Ali Trading Company (Pvt.) Ltd.

Structural Safety Inspection Report

Observations & Actions

Pakistan Accord Initial Safety Inspection Report

Figure 2.2 - Location of Highly Stressed Internal Ground Columns of Football Production 2

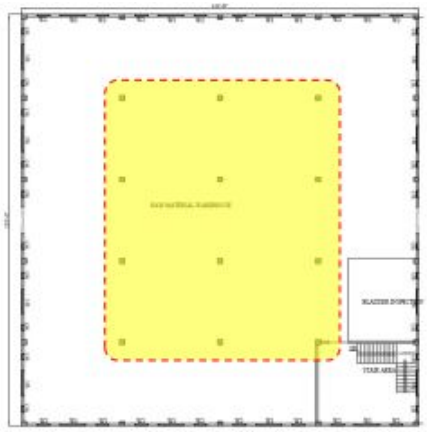
The internal ground floor columns of Football Production 2 were observed to be highly stressed, potentially due to the relatively large structural grid size (9.18 m × 7.68 m), addition of second floor, and absence of verified concrete strength data. These conditions make the structure vulnerable to potential structural distress and reduce the overall reliability of the load-carrying system. F-202604-065240

Timeline	Remediation Plan
Medium Term CAP-0077211	Verify in-situ reinforcement by removing cover and confirming no. and diameter of bars and submit results to Pakistan Accord for review.
Medium Term CAP-0077212	Verify strength of reinforcement through laboratory tensile strength testing and submit results to Pakistan Accord for review.
Medium Term CAP-0077213	Verify in-situ concrete strength for the identified columns either by 100mm dia. cores from at least 4 columns or existing cylinder strength data and submit results to Pakistan Accord.
Medium Term CAP-0077215	Factory Engineer to review design, loads and columns stresses in area identified and submit to Pakistan Accord for review.
Longer Term CAP-0077221	Produce and actively manage a loading plan for all floor plates within the factory giving consideration to floor capacity and column capacity

Figure 2.3 - Covered Opening within the First Floor Slab of Football Production 1 Building

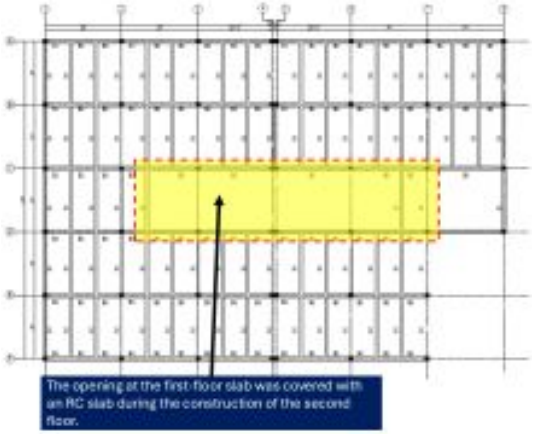
This issue refers to the first-floor slab of Football Production 1. The original opening in the slab was covered with a reinforced concrete (RC) slab during the construction of the second floor. The newly cast slab appears to be unsupported by any internal beams. This condition raises structural concerns regarding its capacity to safely resist vertical loads, control deflection, and perform adequately under lateral loading. F-202604-065682

Timeline	Remediation Plan
Medium Term CAP-0077978	Building Engineer to review the design of structure and propose any strengthening measures as required and submit it to Pakistan Accord for review.
Longer Term CAP-0077979	Implement the Remediation as required.

Figure 2.5 - Location of Exposed Corroded Dowel Reinforcement at the Roof of Football Production 1

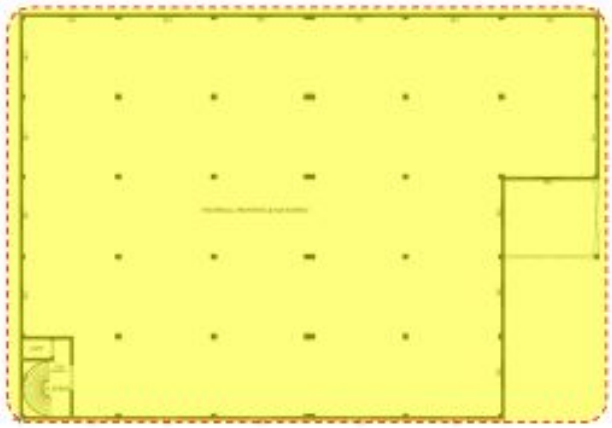
The dowel reinforcement of the column at the roof level of the Football Production 1 has been significantly affected by atmospheric corrosion. This condition may compromise the structural integrity over time. F-202604-065223

Timeline	Remediation Plan
Medium Term CAP-0077173	Propose the remedial measure to protect the dowel reinforcement from future atmospheric corrosion and submit to Pakistan Accord for review.
Longer Term CAP-0077174	Implement the required remedial work.

Figure 2.7 - Location of Exposed Corroded Dowel Reinforcement at the Roof of Football Production 3

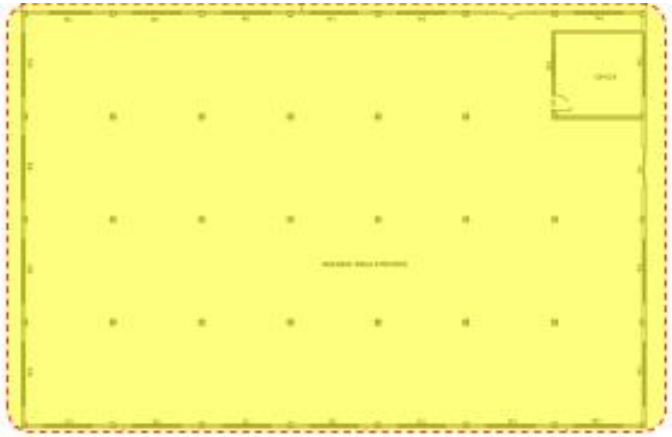
The dowel reinforcement of the column at the roof level of the Football Production 3 has been significantly affected by atmospheric corrosion. This condition may compromise the structural integrity over time. F-202604-065224

Timeline	Remediation Plan
Medium Term CAP-0077175	Propose the remedial measure to protect the dowel reinforcement from future atmospheric corrosion and submit to Pakistan Accord for review.
Longer Term CAP-0077176	Implement the required remedial work.

Figure 2.11 - Location of Damaged RC Columns at the Ground and First Floor of Football Production 3

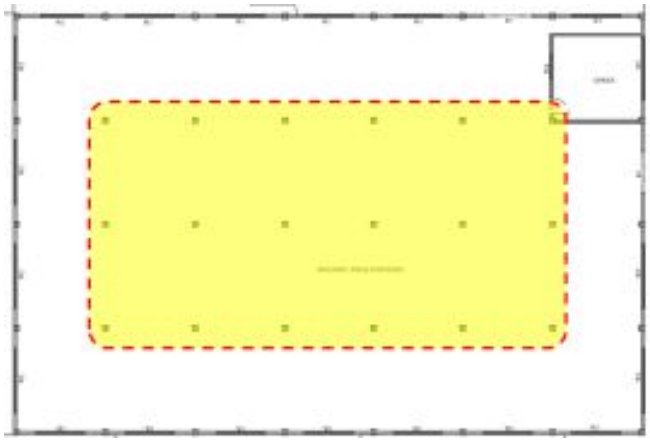
This issue refers to the ground and first floor of Football Production 3.
Damaged RC columns were observed at the ground and first floor which appears to be due to impact, possibly from movement of machines or a loaded trolley.F-202604-065230

Timeline	Remediation Plan
Medium Term CAP-0077179	Propose suitable protection around all RC columns in areas with vehicle or loaded trolley movement to prevent damage and collapse of columns from potential impacts and submit it to Pakistan Accord for review.
Longer Term CAP-0078696	Implement the required remedial works.

Figure 2.14 - Location of the Welder Shop

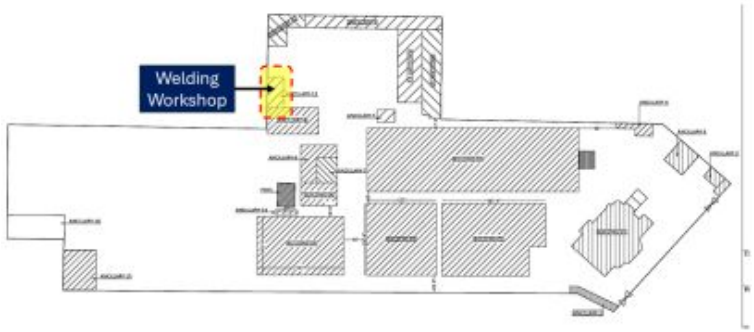
Excessive deflection was observed in the steel trusses, purlins, and roofing sheets of the welding workshop. Furthermore, misalignment of steel columns was noted. These deficiencies indicate compromised structural performance and pose a potential risk of structural instability and collapse. F-202604-065235

Timeline	Remediation Plan
Immediate CAP-0077195	The area shall be evacuated .
Medium Term CAP-0077196	Building structural engineer to review the as-built design for code compliance (vertical and lateral loads) and confirm if it is adequate.
Medium Term CAP-0077197	Propose strengthening works as required and submit to Pakistan Accord for review.
Longer Term CAP-0077198	Implement strengthening works as required.

Figure 2.17 - Red Line Indicated Missing Edge Protection at the Roof of Football Production 1

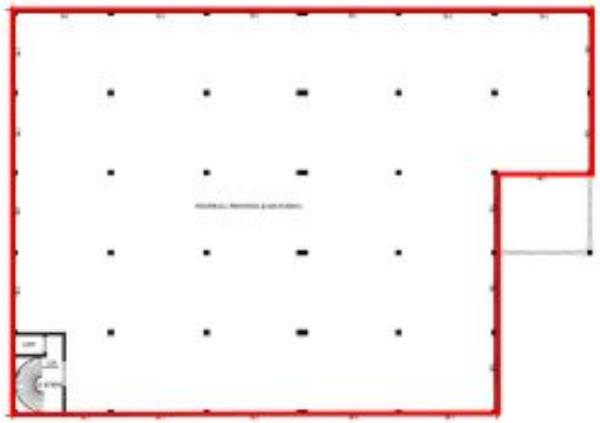
It concerns with lack of edge protection at the roof of the Football Production 1 which present a risk of potential injury resulting from slip, trip or fall from roof during the access and maintenance of services – Health & Safety concern. F-202604-065226

Timeline	Remediation Plan
Immediate CAP-0077181	Provide adequate edge protection on the roof, and on any other part of the factory with the same issue.

Figure 2.19 - Red Line Indicated Missing Edge Protection at the Roof of Football Production 3

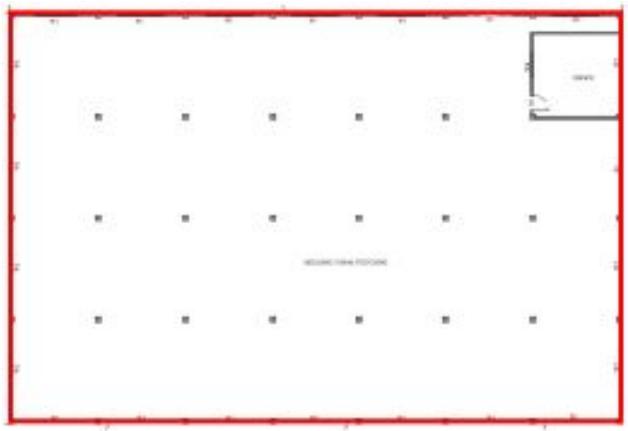
It concerns with lack of edge protection at the roof of the Football Production 3 which present a risk of potential injury resulting from slip, trip or fall from roof during the access and maintenance of services – Health & Safety concern. F-202604-065227

Timeline	Remediation Plan
Immediate CAP-0077183	Provide adequate edge protection on the roof, and on any other part of the factory with the same issue.

Figure 2.23 - Location of Steel Staircase in the Football Production 1 Building

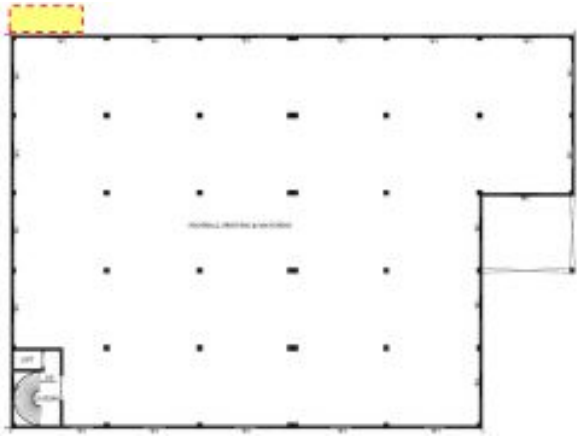
This issue refers to the steel stairs in the Football Production 1 Building. The stairs might have undersized structural elements and lack proper bracing, making them highly vulnerable. F-202604-065232

Timeline	Remediation Plan
Medium Term CAP-0077189	Building structural engineer to review the as-built design for code compliance (vertical and lateral loads) and confirm if it is adequate.
Medium Term CAP-0077190	Propose strengthening works as required and submit to Pakistan Accord for review.
Longer Term CAP-0077191	Implement strengthening works as required.

Figure 2.25 - Location of Steel Staircase in the Football Production 2 Building

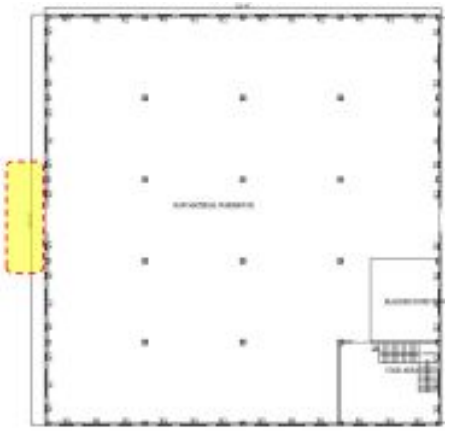
This issue refers to the steel stairs in the Football Production 2 Building. The stairs might have undersized structural elements and lack proper bracing, making them highly vulnerable. F-202604-065234

Timeline	Remediation Plan
Medium Term CAP-0077192	Building structural engineer to review the as-built design for code compliance (vertical and lateral loads) and confirm if it is adequate.
Medium Term CAP-0077193	Propose strengthening works as required and submit to Pakistan Accord for review.
Longer Term CAP-0077194	Implement strengthening works as required.
